Overview: Production error; immobilizer wire (orange/black) in pin position #4 instead of pin position #5. Although an effort to correct the issue was made, some quantity of harnesses did get shipped before the issue was spotted. We are advising to inspect the harness BLADE connector before attempting to install the harness and program the module.

Overview: The FTI-STP1 harness may require modification for use in **automatic transmission (AT)** applications, some of the product was able to be modified before release, but a small quantity was released before being able to be modified internally.

FTI-STP1: Installation and Configuration Notes

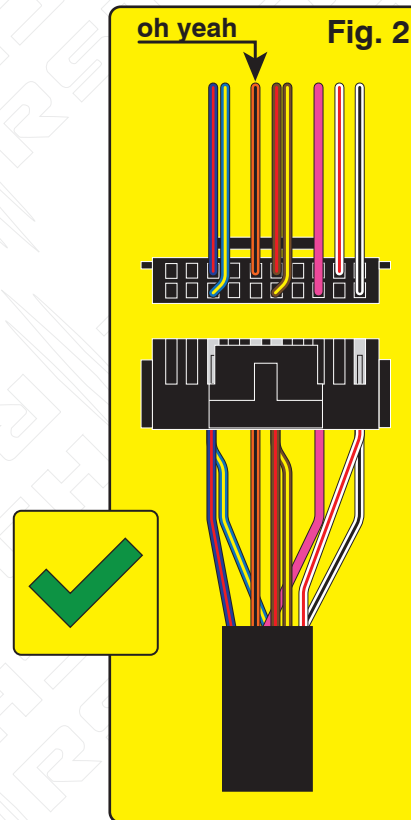
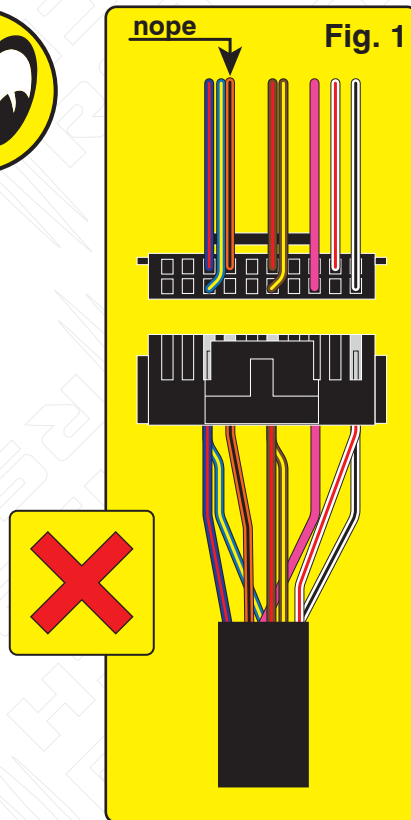
Issue: Module fails to program to vehicle, will not allow the vehicle to be remote started.

Correction: Step 1.) Locate the orange/black wire and confirm whether it is positioned as illustrated in Fig. 1 or Fig. 2. If the wire is as illustrated in Fig.1, proceed with Step 2 through 5 and complete the repair procedure outlined, if the wire is as illustrated in Fig. 2, correction is not necessary, proceed with harness installation and module programming.

Step 2.) Using a pick, lightly depress the catch that secures the terminal in the housing then remove the wire and terminal from the housing.

Step 3.) Using a fine tip razor or utility knife, insert the blade beneath the terminal catch and raise it slightly, so that it can be reused to secure the terminal when reinserted into the BLADE connector housing.

Step 4.) Refer to Fig. 2 for correct position of the orange/black wire (next to brown/red) then reinsert the terminal, pressing lightly until the catch 'snaps' into place, securing the terminal in the connector housing.

MODIFICATION REQUIRED FOR AUTOMATIC TRANSMISSION APPLICATIONS ONLY

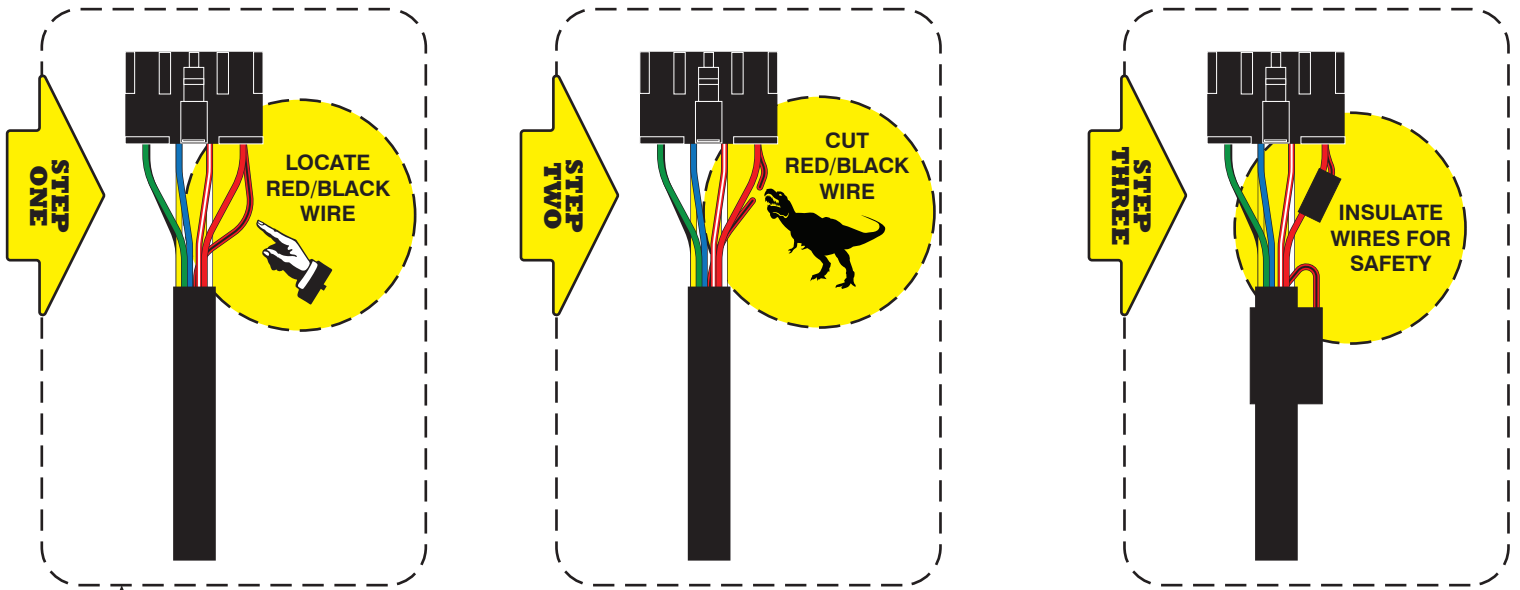
Issue: The FTI-STP1 T-harness has been designed to be compatible with AT (automatic transmission) & MT (manual transmission) applications, but due to a production oversight, the selection mechanism was defaulted to MT mode.

Using a harness configured for an MT application, in an AT equipped vehicle, could result in vehicle module damage, it is advised that the harness be returned to AT mode before installation in vehicles equipped with an automatic transmission.

Correction: Locate the **red/black (+ Clutch)** wire provided in the CN1 connector of the main harness assembly. Cut the **red/black** wire, either flush to the CN1 connector, or leaving enough wire exposed so that you can insulate and secure the ends of the wire that remain after cutting. Insulate each of the remaining ends of the **red/black** wire and secure to prevent any possibility of a short circuit.

If the red/black wire already been disconnected, no further modification is required for AT equipped vehicles.

MODIFICATION NOT REQUIRED WHEN USING FTI-STP1 HARNESS IN MANUAL TRANSMISSION APPLICATIONS

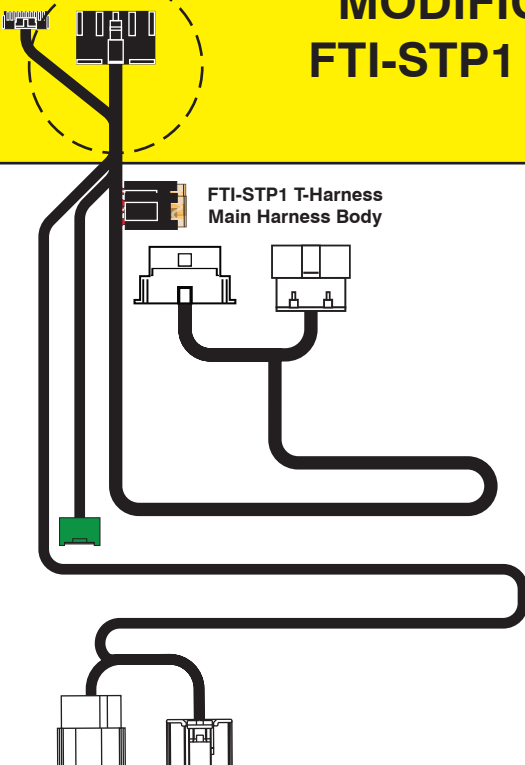
CMX, CM7, and CM9 Series controllers: No configuration changes required. *See previous page for modification required at the CN1 connector parking light (+ clutch) output position .*
